## TOWN OF YORKTOWN PLANNING BOARD

### PUBLIC MEETING AGENDA YORKTOWN TOWN HALL BOARD ROOM 363 Underhill Avenue, Yorktown Heights, NY 10598

October 18, 2021  
7:00 PM

3. **Bird Bus Sales & Service  
Public Hearing**

### Preliminary Layout and Landscape Plan

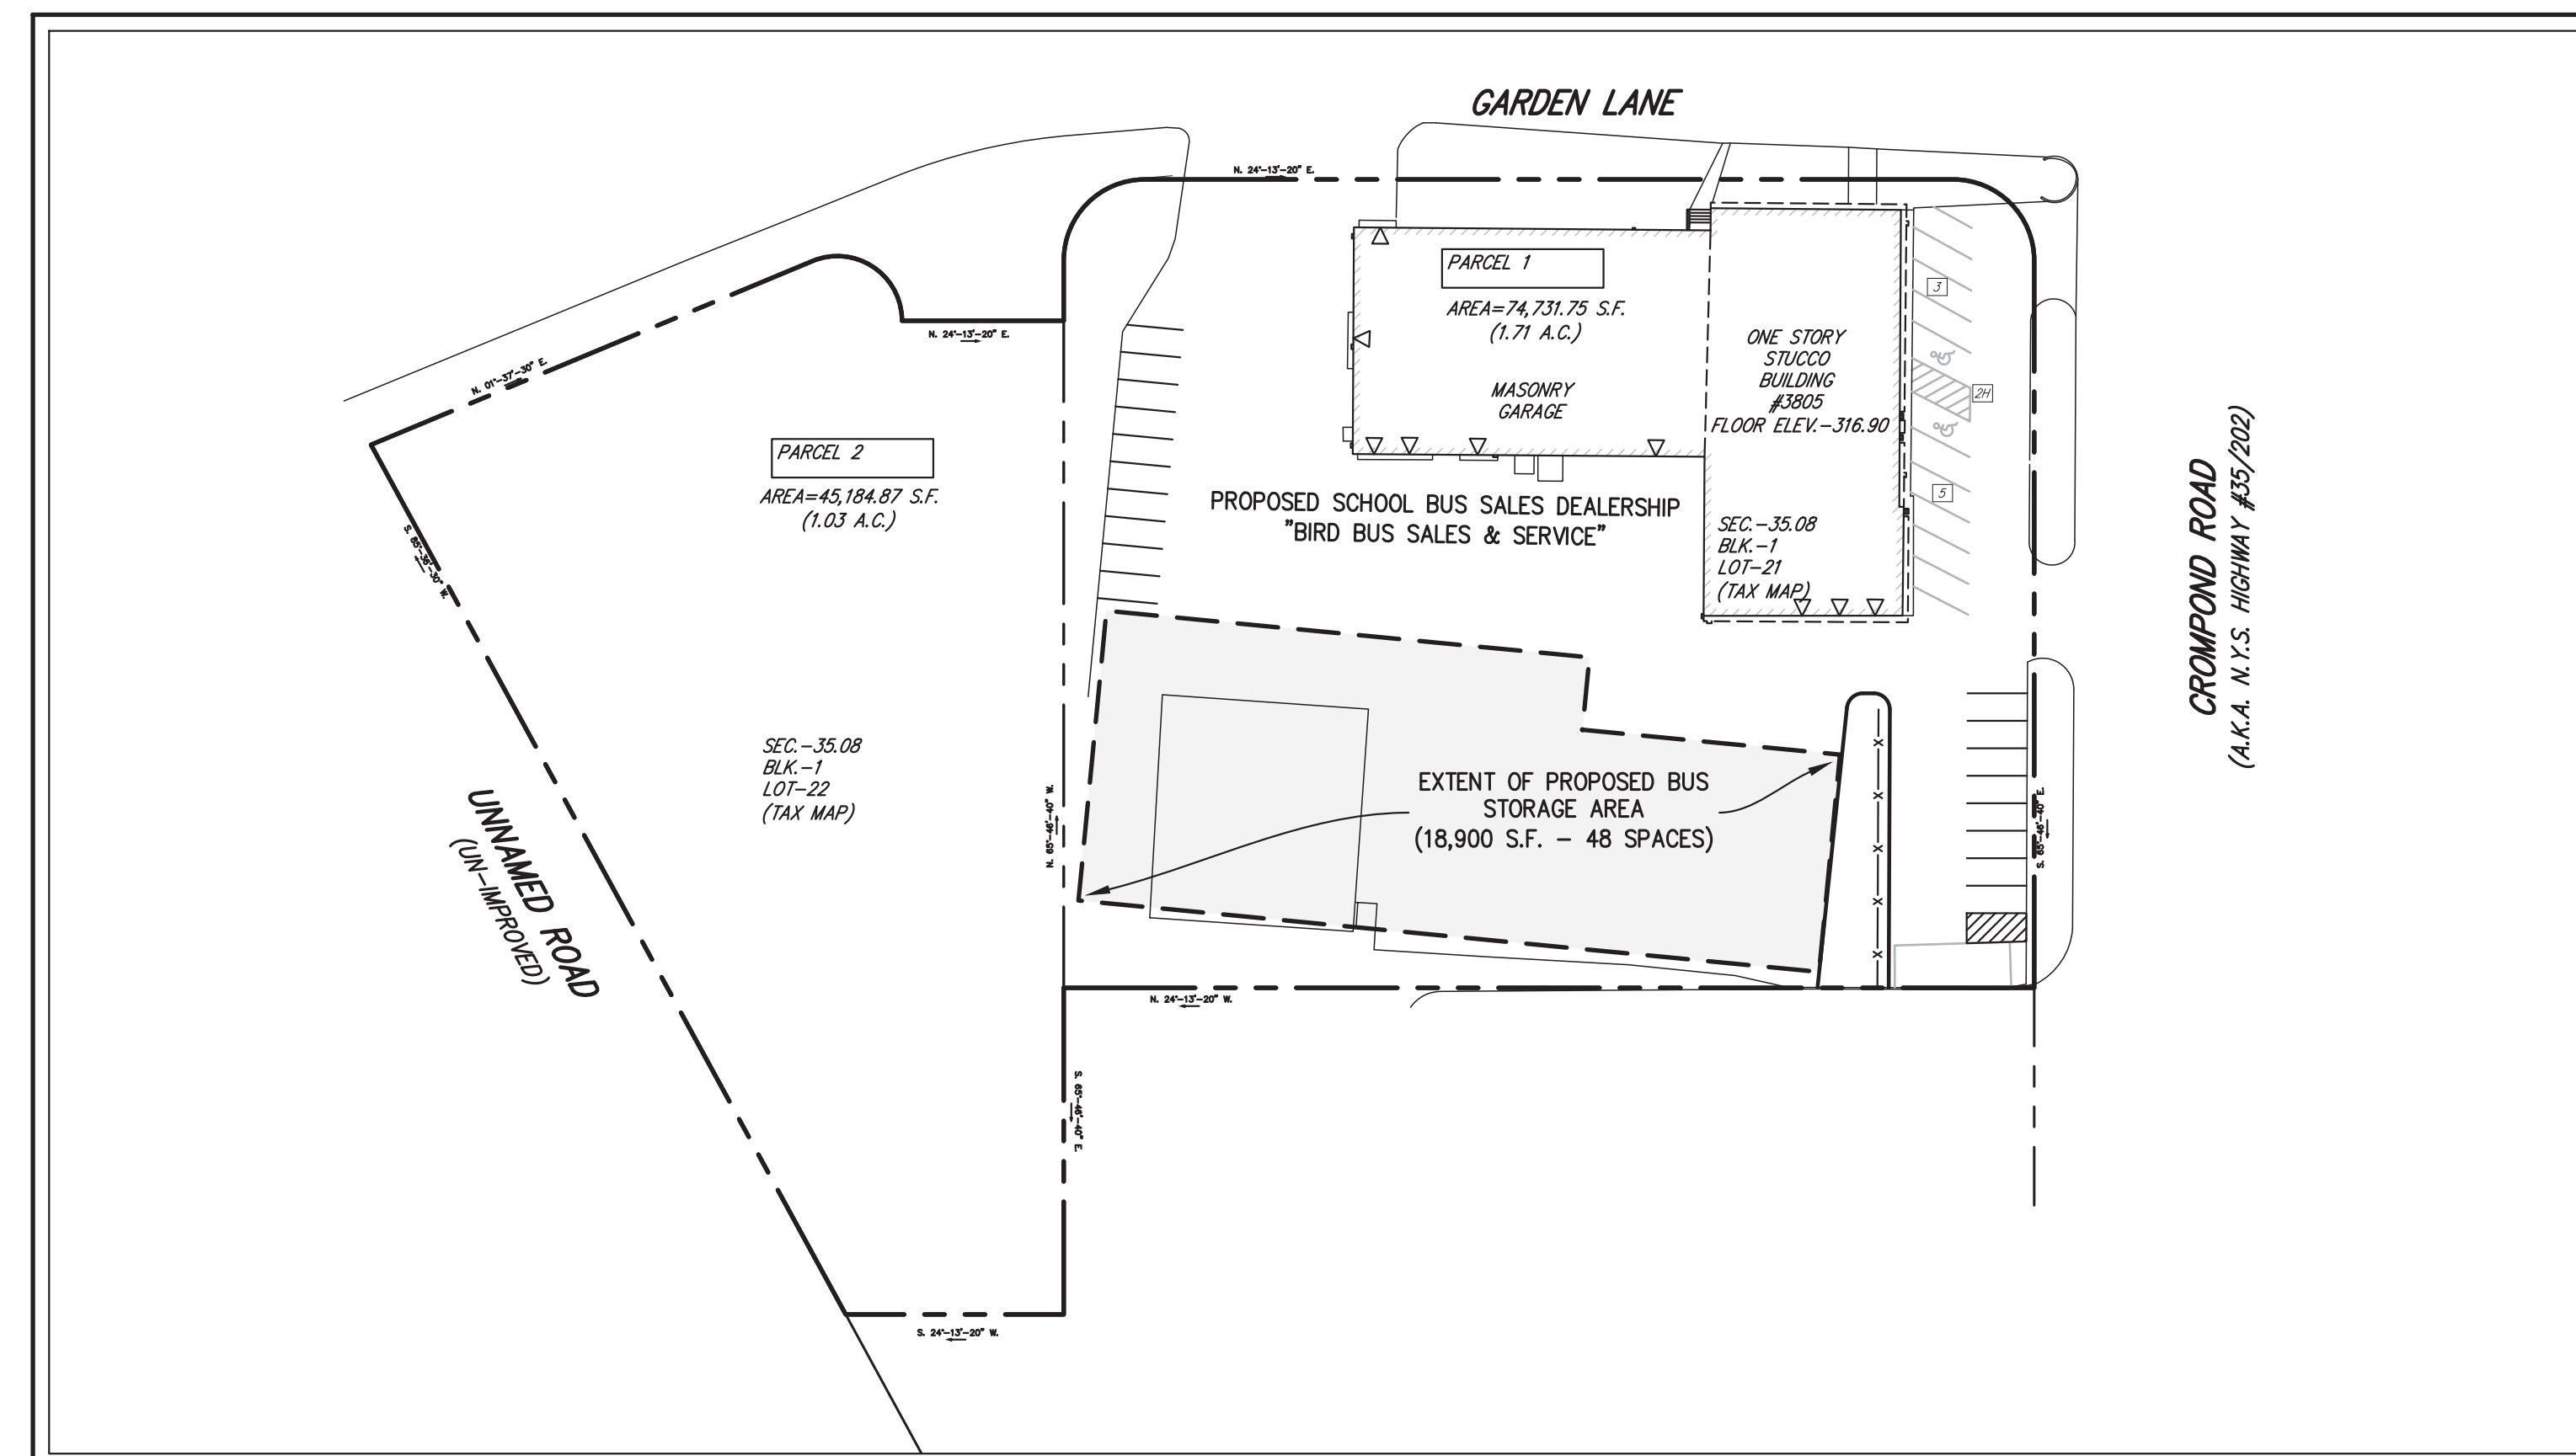
- The Board suggests for the applicant to screen the right side of the building with arborvitae similar to the front.
- The Board requests for the applicant to move the fence at the parking to be behind the arborvitae.
- The Board requested for the applicant to add plantings to the streetscape. These plantings would be within the NYSDOT right-of-way. The applicant must confirm that the proposed plantings meet the NYSDOT requirements.
- The Board requests for the applicant to submit a detailed landscape plan for review.

JMC Drawing C-100, "Site Layout and Landscaping Plan", has been revised to propose plantings along the property's Garden Lane frontage adjacent to the garage building.

JMC Drawing C-100, "Site Layout and Landscaping Plan", has been updated accordingly.

Please see JMC Drawing C-100, "Site Layout and Landscaping Plan", which details the site landscaping.

1 FRONT ELEVATION  
SCALE: 1/8" = 1'-0"

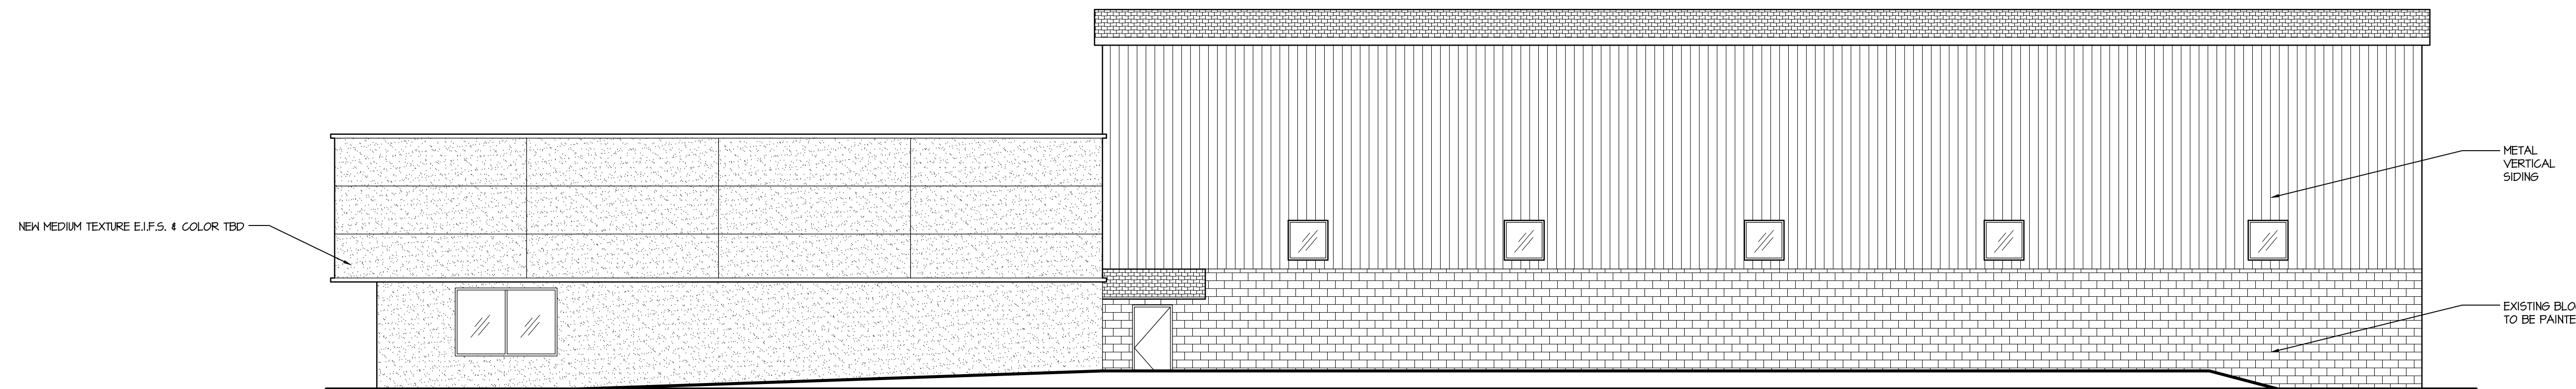
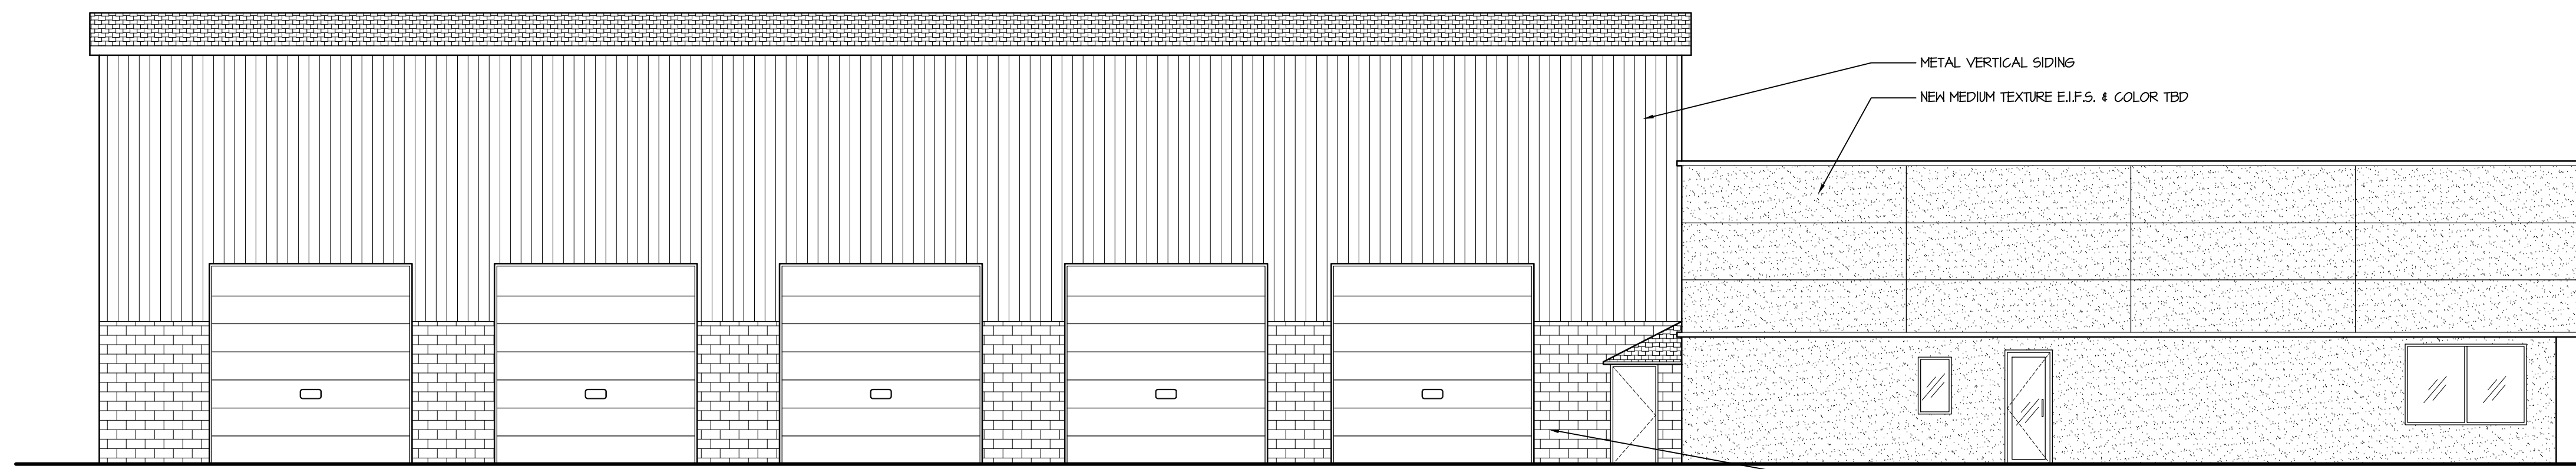
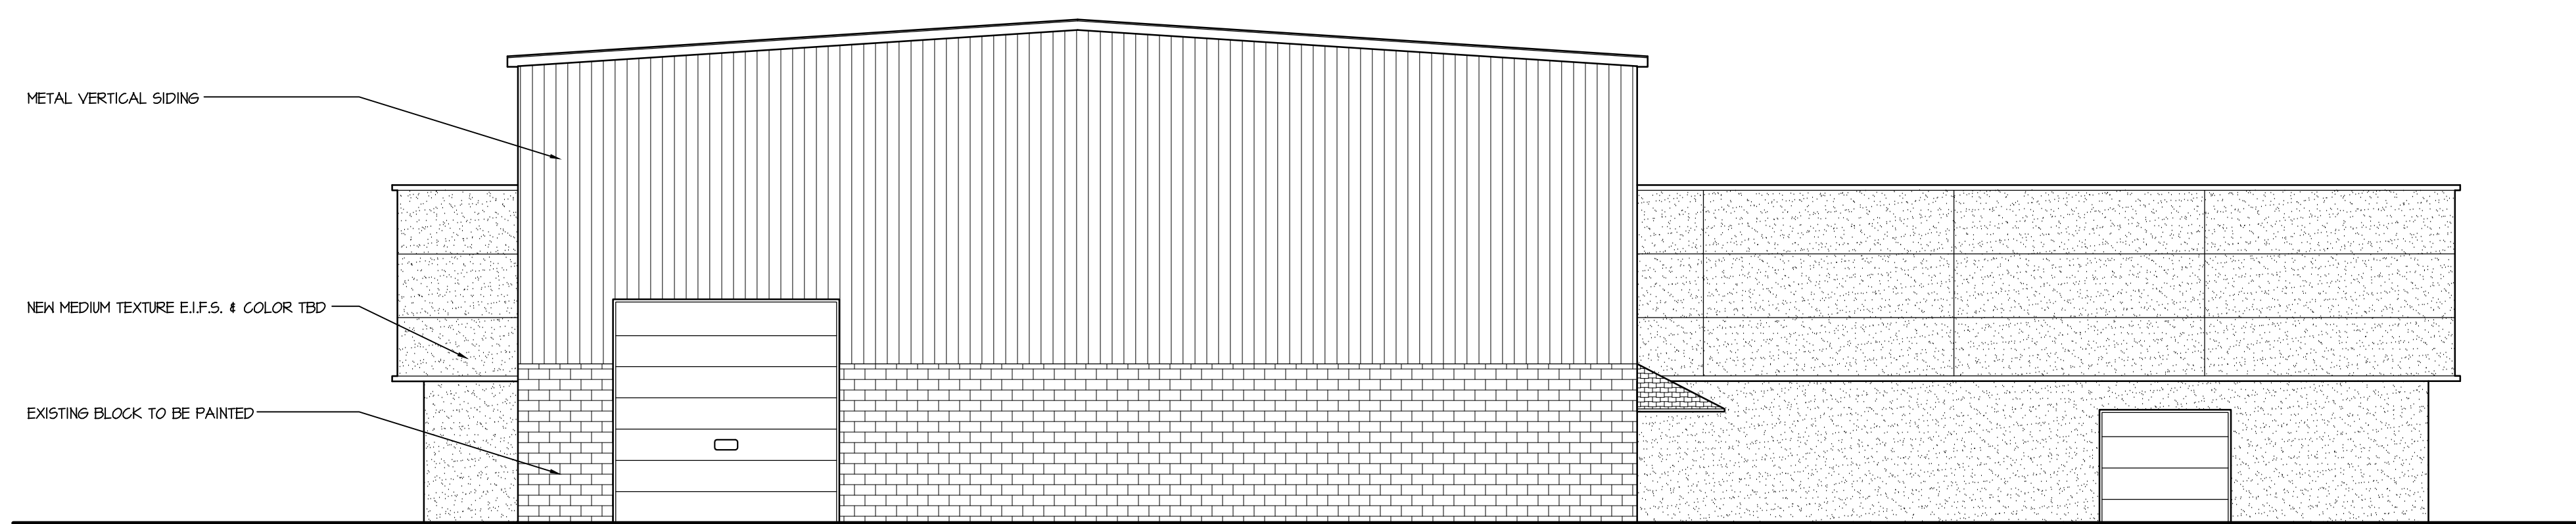
*The Board suggests for the applicant to add windows to the service building, one per bay on each side or clerestory units, for aesthetic purposes since the proposed facade is large and bare. This will also allow for natural light into the work area.*

The floor plan and elevations have been revised to add windows along this elevation at each bay.
